# UNITED STATES PATENT AND TRADEMARK OFFICE

APPLICATION NO.	FILING DATE	FIRST NAMED INVENTOR	ATTORNEY DOCKET NO.	CONFIRMATION NO.
09/492,369	01/27/2000	Willliam E. Blaha		9790
7	590 03/31/2003			
Joel H. Bock Dorn, McEachran, Jambor & Keating 55 E. Monroe Street			EXAMINER	
			NGUYEN, TRUC T	
Suite 2940 Chicago, IL 6	0603		ART UNIT	PAPER NUMBER
			2833	<del></del>

A titi N-	10-1:4->
	Application No.	Applicant(s)
Office Action Commons	09/492,369	BLAHA, WILLLIAM E.
Office Action Summary	Examin r	Art Unit
	Truc T. T. Nguyen	2833
The MAILING DATE of this communication app Period for Reply	pears on the cover sheet with the	correspondence address
A SHORTENED STATUTORY PERIOD FOR REPL THE MAILING DATE OF THIS COMMUNICATION.  - Extensions of time may be available under the provisions of 37 CFR 1.1 after SIX (6) MONTHS from the mailing date of this communication.  - If the period for reply specified above is less than thirty (30) days, a repl - If NO period for reply is specified above, the maximum statutory period of Failure to reply within the set or extended period for reply will, by statute - Any reply received by the Office later than three months after the mailing earned patent term

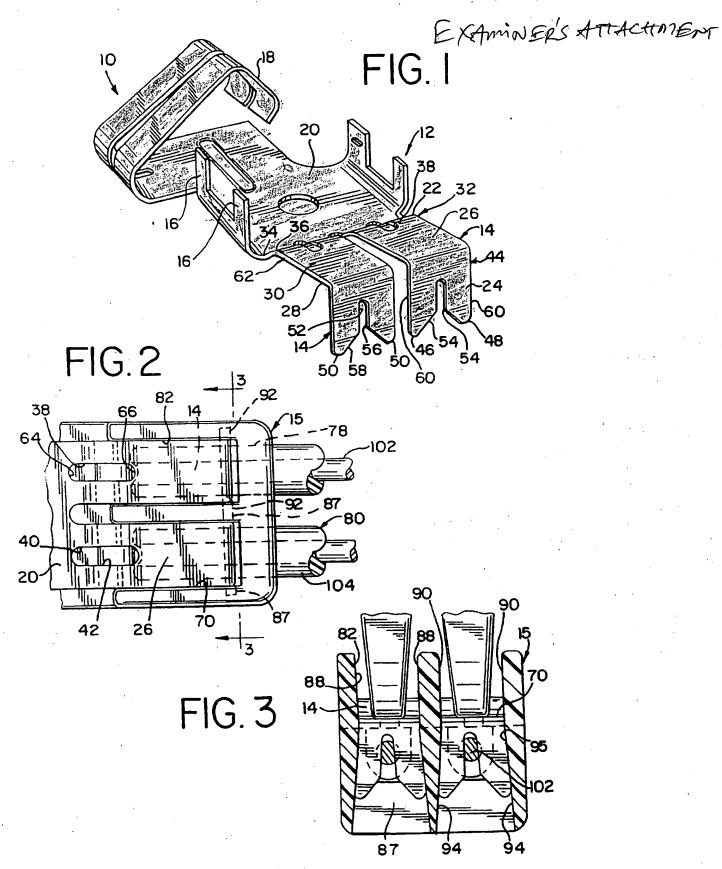
Regading claims 1-2 and 5, Sowinski discloses a wire connector (10) comprising:

a housing (15) define cavity (70) therein with openings (78);

an electrically conductive clip (red portion, see Examiner's attachment) having at least first and second retaining finger (14, 14) forming an insulation displacement type contact, each of which engages an individual conductor (80); and

a blade-type electrically conductive extension (blue portion, see Examiner's attachment) in shorting electrical engagement with the clip and extending through a

housing wall to an exterior of the housing, at least a portion of the extension on the exterior of the housing being electrically conductive.

Regarding claim 3, Sowinski discloses the housing includes two parts the base (72) and the cap (un-numbered, top surface of the housing 15).

Regarding claim 4, Sowinski discloses the conductive clip has a plurality of fingers (24) forming a push-in type connector.

Sowinski discloses a method of electrically connecting two or more wire (80) to a common terminus (not shown, a terminal that engages to conductive extension 18), comprising the step of providing a push-in wire connector (10) having a conductive clip (12), providing a electrical connecting extension (18) electrically shorted to the clip and extending to the exterior of the housing, pushing the stripped end into the housing and into engagement with the clip, and attaching the extension to said terminus.
